11 B0200031

## SB, Trimmy S II, 2002-06

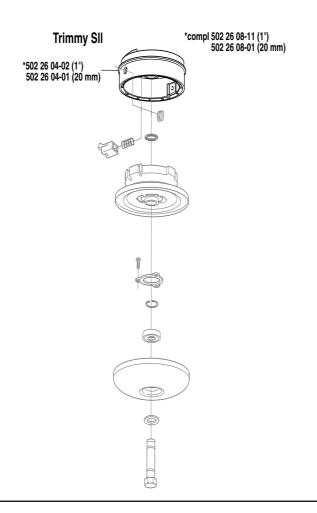
We will be changing the driver and support flange on a number of machines so that they can accept cutting attachments with a 1" centre hole.

This applies to models 227, 232, 240RJ/RBD, 235, 142R, 142RBD and 152RBD. These were previously designed for a 20 mm centre hole.

Before the Trimmy S II can be used on these machines with a 1" driver, a new top section (reel housing) must be fitted that has a modified washer on top.

The new top section (reel housing) that is designed for the 1" driver will also fit earlier machines with a 20 mm driver.

The new reel housing will therefore fit older versions of Trimmy S II.

New part no.	Description	Excl. part no.	Remark
502 26 04-02	Reel housing	502 26 04-01	
502 26 08-11	Trimmy S II	502 26 08-01
